Rexroth HydraulicDrive

HDx-20VRS
Firmware for drive controllers

Firmware Release Notes
RE 30330-RN

2025-05

Fig. 22-1: Definition of input and output data in one module

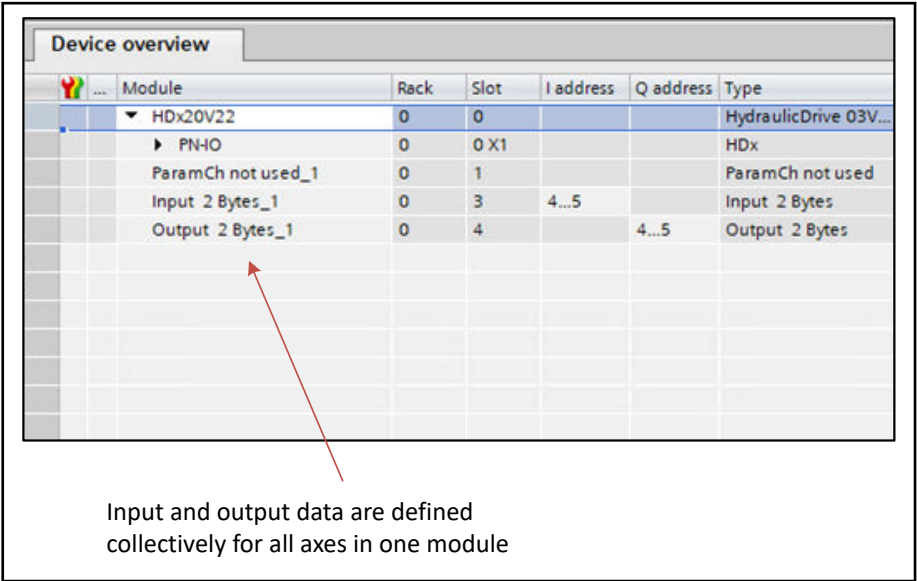
22.1.1 VT-HMC with 2 axes - correction of PROFINET configuration required in the master

Description Within the framework of release HDx20V22 the PROFINET interface of the HydraulicDrive devices was extended. Therefore, the PROFINET interface of the VT-HMC with 2 axes (R901441904, VT-HMC-2-1X/M-0-00/00) had to be adapted. So far, the input and output data were defined for each axis of the VT-HMC in separate modules. **As of release HDM20V22 the input and output data have to be defined for all axes together in one module.**

For the configuration of the VT-HMC with 2 axes the current description file **GSDML-V2.4-Bosch_Rexroth_AG-011F-Hydraulic-Drive_03V00-20210608.xml** has to be used.

1. Download the firmware HDM20V22 to the VT-HMC
2. Upload the current description file GSDML-V2.4-Bosch_Rexroth_AG-011F-HydraulicDrive_03V00-20210608.xml
3. Correct the input and output data
